SERVICE INFORMATION NO. SI D4-077

Garmin - Service Bulletin No. 0736

NO.: 0736

G1000 System ID Tool

Figure 1. Example AUX – System Status Page

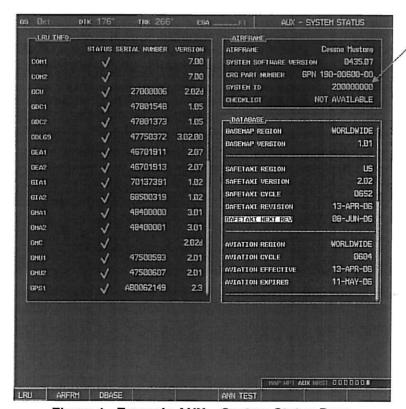
Garmin has identified an error associated with G1000 system software upgrades that sometimes results in an invalid System ID. An invalid System ID can be identified as either being "00000000" or "20000000". The G1000 System ID can be verified on the AUX-System Status Page (Figure 1).

All GDU 1XXXs with a System ID of "00000000" or "20000000". The G1000 System ID can be verified on the MFD AUX-System Status Page (Figure 1).

- Verify the System ID is not "00000000" or "20000000" on the MFD AUX-System Status page.
- Verify optional features (TAWS, ChartView, etc.) are active.
- Verify no database errors exist in the ALERT window.
